Docket Item # 4
BAR CASE # 2008-0157

BAR Meeting
October 1, 2008

ISSUE: Alterations
APPLICANT: John Gero
LOCATION: 621 Pommander Walk Street
ZONE: RM/Residential

BAR CASE #2008-0157

Figure 1: Existing Photos

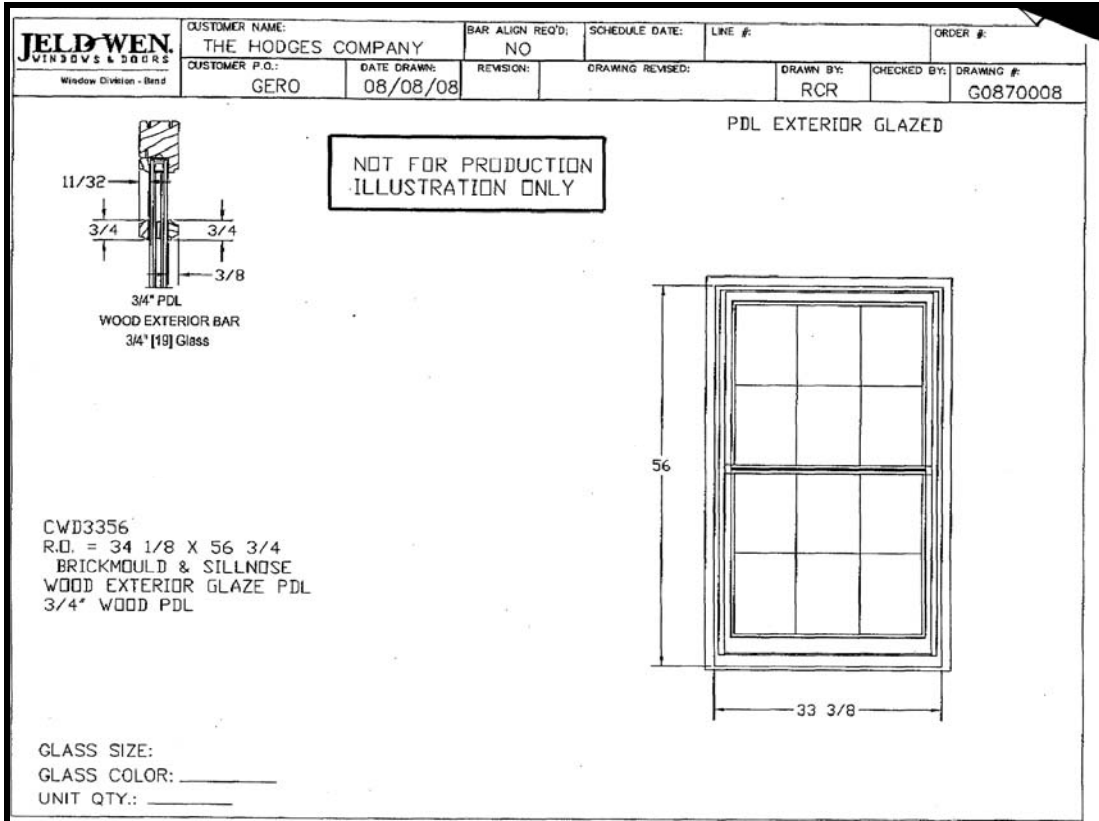
621 Pommander Walk: Front Windows and French Doors
Replacement: same material, same design, same color

621 Pommander Walk: Rear Window Wall
Replacement: same material, same design, same color

Figure 2: Proposed Windows

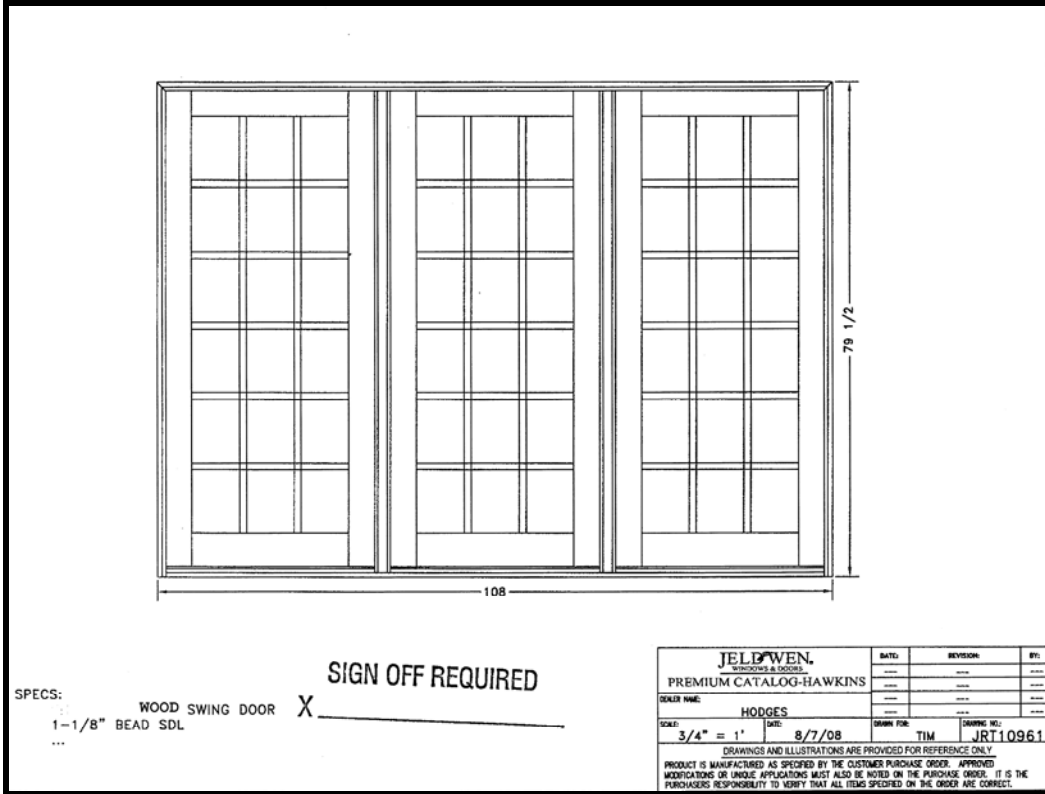
The applicant proposes to replace five double-hung windows and two pairs of French doors on the front elevation, as well as the patio level French doors on the rear of the house. The existing windows are single-glazed, six-over-six wood windows with exterior storms. The applicant is requesting approval of Jeld-Wen double-insulated wood windows and doors. They are proposed to be simulated divided lights with ¾” muntins and an interior spacer bar. The trim will be painted white.

The *Design Guidelines* recommend that: “...replacement windows should be appropriate to the historic period of the architectural style of the building”. The *Guidelines* also state that single-glazed, true divided light windows with interior storm sash are the preferred replacement window type. The *Guidelines* continue by saying that other acceptable window types are “double-glazed, true divided light wood windows...Windows with fixed or applied muntins have been approved for the rear elevation of a structure which has minimal visibility from a public right of way.” In this particular case, given the age of the townhouse and the fact that the existing size, light pattern and muntin profile will be retained, Staff does not object to the installation of the proposed double-insulated windows and doors

Staff recommends approval of the application as submitted.
